APPLICATION NO.	FILING DATE	FIRST NAMED INVENTOR	ATTORNEY DOCKET NO.	CONFIRMATION NO.
10/559,609	12/02/2005	Shinji Eritate	03500.103418.	1529
5514	7590	06/15/2009		
FITZPATRICK CELLA HARPER & SCINTO 30 ROCKEFELLER PLAZA NEW YORK, NY 10112				EXAMINER
				ECHELMEYER, ALIX ELIZABETH
ART UNIT		PAPER NUMBER		
		1795		
MAIL DATE		DELIVERY MODE		
06/15/2009		PAPER

Office Action Summary	Application No.	Applicant(s)
	10/559,609	ERITATE ET AL.
	Examiner Alix Elizabeth Echelmeyer	Art Unit 1795

DETAILED ACTION

FIG. 1

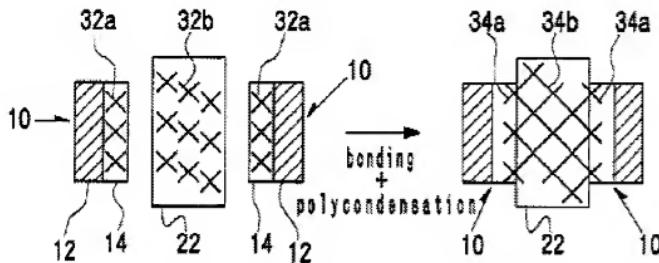
As for Applicant's argument that Tsusaka et al. do not disclose or suggest infiltrating polymer electrolytes into the catalyst layer, the examiner again disagrees. As

discussed above, Tsusaka et al. teach that the metallocxane polymer is found in both the catalyst layer and the membrane. It is cross-linked such that the material in the catalyst layer is connected to the material in the membrane. As seen in Figure 1 of Tsusaka et al., the cross-linking leads to infiltration of the membrane material into the electrode catalyst layer.
